City of Portland, Maine - Building or Use Permit Application 389 Congress Street, 04101, Tel: (207) 874-8703, FAX: 874-8716

BUILDING PERMIT REPORT

REASON FOR PERMIT: replace slab / Foundation

LAND USE - ZONING REPORT

These are approx.
distances for plot plan
done by homeowner
11 Maplewood St.
878-3224.

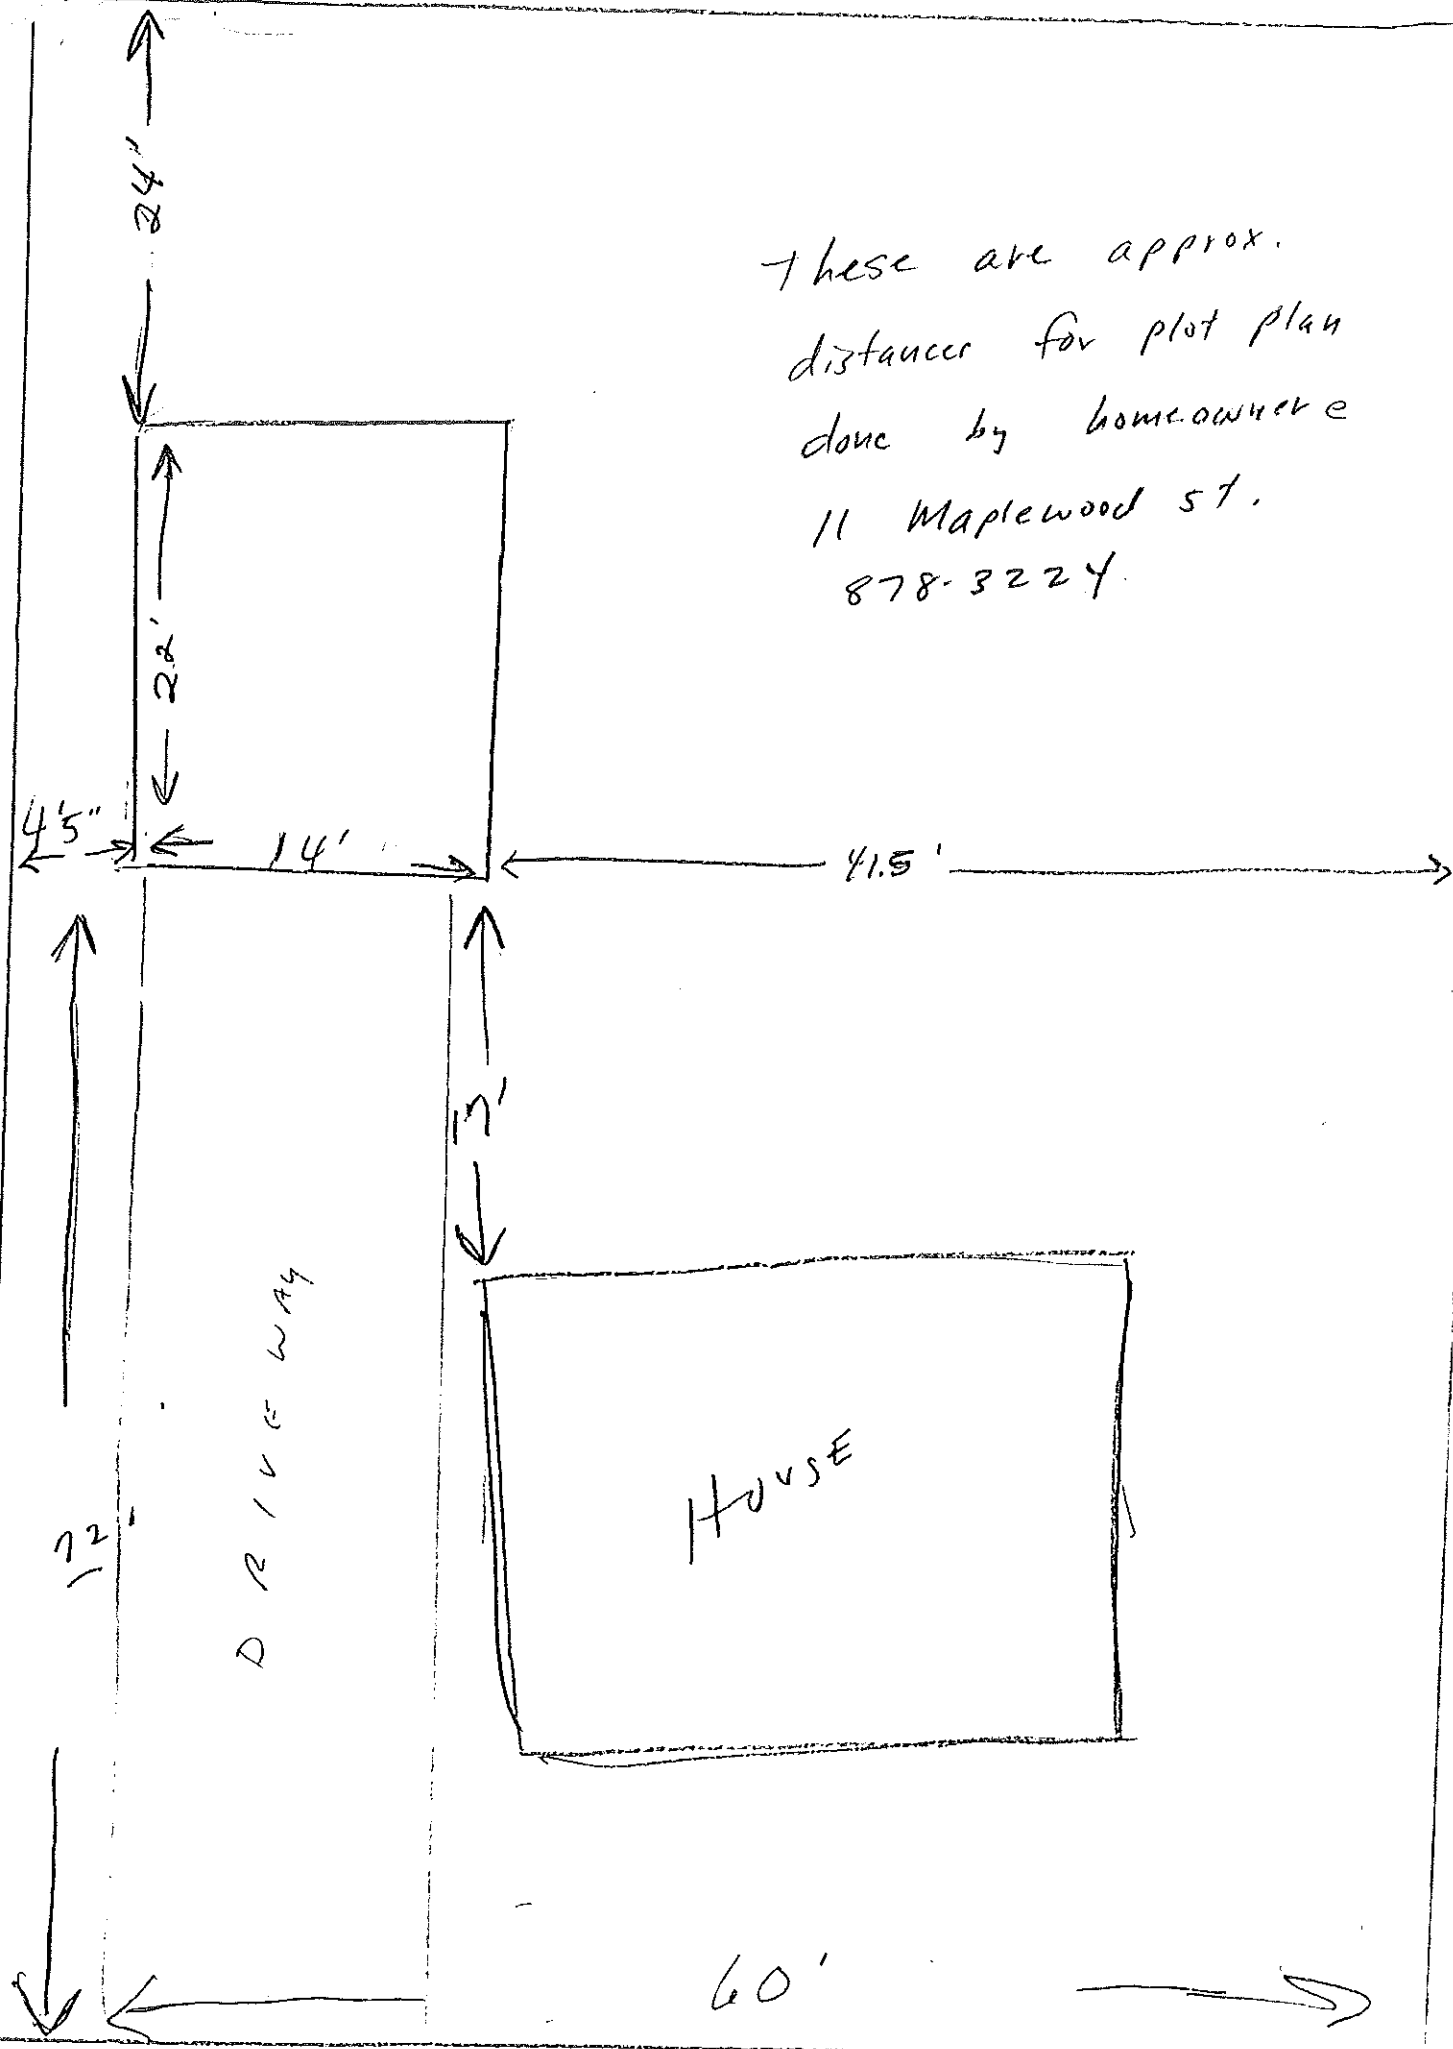
← 39' 10" →
 Back of House to Rear of Garage

Rear Left corner of house to Front of Garage
 18' 1" R.S. and 22' 4" L.S.
 Rear Right corner of house to Front R and Rear Right
 of Garage 37' 4" 51' 7"

Distances taken on 10-13-98
 By Tom Reinboroug + owner Anne Marley
